32-Bit Microcontroller V850/SA1  Usage Restrictions		Document No.	SBG-T-2476-E	1/2
		Date issued	September 12, 2001	
		Issued by	Microcomputer Engineering Dept. Solution Engineering Div. NEC Electron Devices NEC Corporation	
Related documents	User's manual -Hardware: U12768EJ	Notification classification	√	Usage restriction
	User's manual -Architecture: U10243EJ			Upgrade
	Data sheet (Flash memory): U14527EJ			Document modification
	Data sheet (Mask ROM): U14526EJ			Other notification
	Application note: U13851EJ

### 1. Affected products

$\mu$ PD70F3017/F3017Y/F3017A/F3017AY (on-chip flash memory/RAM: 256KB/8KB)

Figure) NOP Insertion Program Flowchart

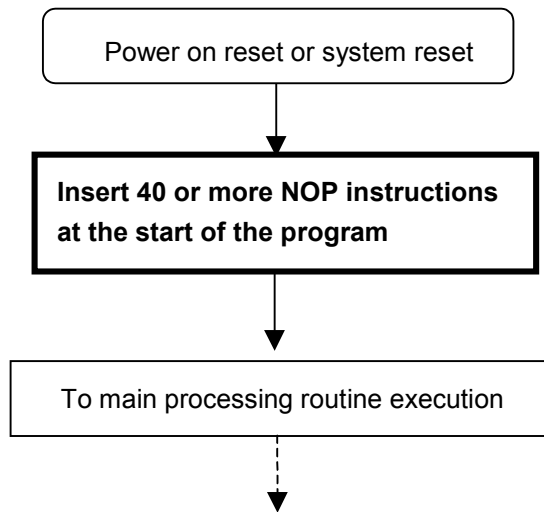
The microcontroller may become inoperable after the power is turned on or the system is reset.

It is necessary to secure time for the voltage to rise sufficiently before the first fetch of the program. To do this, please insert **40 or more** NOP instructions at the start of the program.

(1) When using NMI

If an NMI is used (handler address: 00000010H), it is recommended to change it to external input maskable interrupt INTP0 (handler address: 00000090H), etc.

(2) When using NMI

If non-maskable interrupt INTWDT (handler address: 00000020H) of the watchdog timer is used, it is recommended to change it to maskable interrupt INTWDTM (handler address: 00000080H) of the watchdog timer.

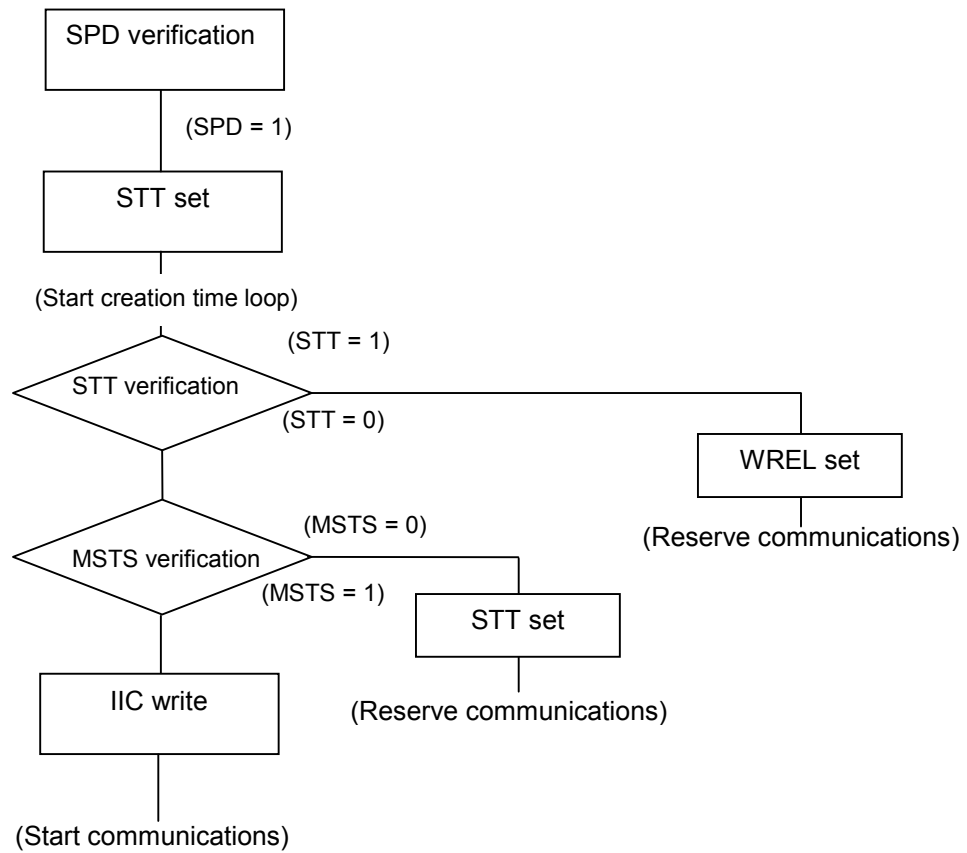
#### (4) Conflict between STT set timing and start condition detection

The following bugs may occur as a result of conflict between STT set timing and start condition detection.

- STT bit set operation may be rejected.
- The device may be incorrectly recognized as the master (MAST = 1) and the STT bit cleared.
- A WAIT condition may result from a fall in SCL if STT is set and SCL is in a high-level state (SPD = 1) when the target device has generated a start condition.

STT set timing (during multi-master operation)

Provide software that performs the operations in the flow chart below.

Ensure that the time from SPD verification to WREL set in the above flow chart is as follows.

In high-speed mode: 17.5  $\mu$ s or less

In standard mode: 70.0  $\mu$ s or less

Figure 2. Interrupt Processing Causing This Bug

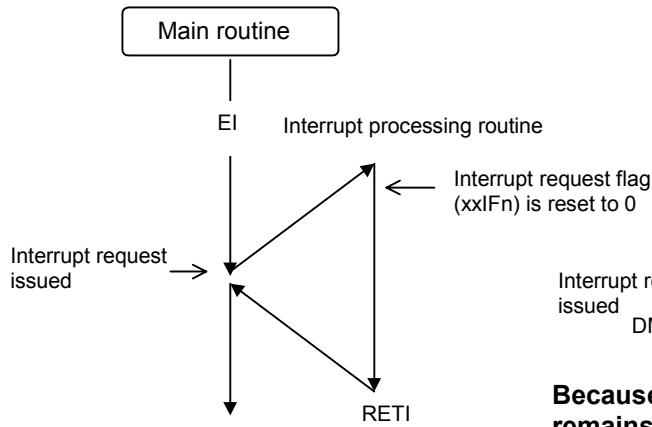
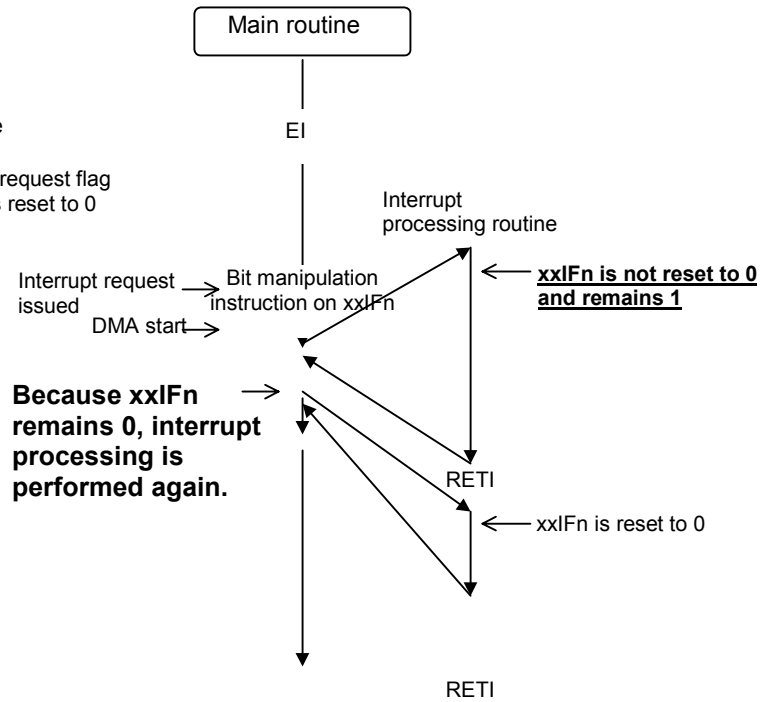
If the three conditions below occur at the same time while interrupts are enabled (EI), an interrupt that should only occur once occurs twice.

- (1) A bit manipulation instruction (set1, clr1, not1, tst1) is executed on an interrupt request flag (xxIFn) of an interrupt control register (xxICn).
- (2) Interrupt processing occurs involving the hardware of the same register as in (1).
- (3) DMA is started while executing the above bit operation instruction.

When the above conditions (1) to (3) coincide and interrupt processing begins, the interrupt request flag that should be reset by hardware is not reset, so that after returning from the interrupt processing routine (RETI instruction), the interrupt processing is executed again. (See figures 1 and 2.)

**Example** During a bit operation on the interrupt request flag (CSIF0) of the CSIC0 register using the clr1 instruction, the non-masked INTCSI0 interrupt occurs, which then conflicts with the start of DMA. In this case, the INTCSI0 interrupt processing is executed twice.
